# Initial Project Review

## Rezone / Planned Development District / Preliminary Plat / Site Plan Review: Elk Plain Crossing PDD

**Application Numbers: 896267, 896277, 898393, 896281, 896280**

# Proposed Preliminary Plat Map, revised March 11, 2019

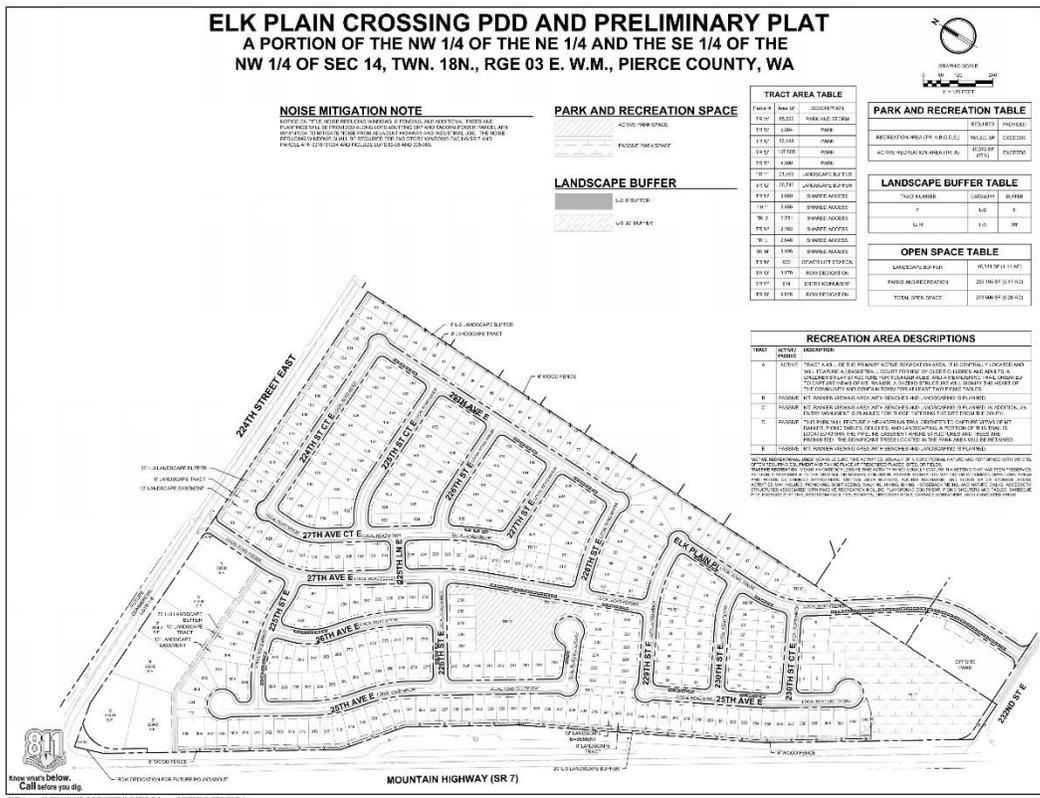
- The site plan proposes to use rolled curbing on the internal local minor roadways. This will need to be revised to use vertical curbing per the Pierce County Road Standards.

- The right Angle "L" intersection between 27th Ave Ct E/227th St E does not meet standards and will need to be revised prior to plan approval. The intersection angle needs to be at 90 degrees.

- The proposed Phase 1 will result in a road system that does not meet County Standards, as there would be too many lots accessing on what would be considered a cul-de-sac. This should be discussed in the traffic analysis and a public road deviation would be required.
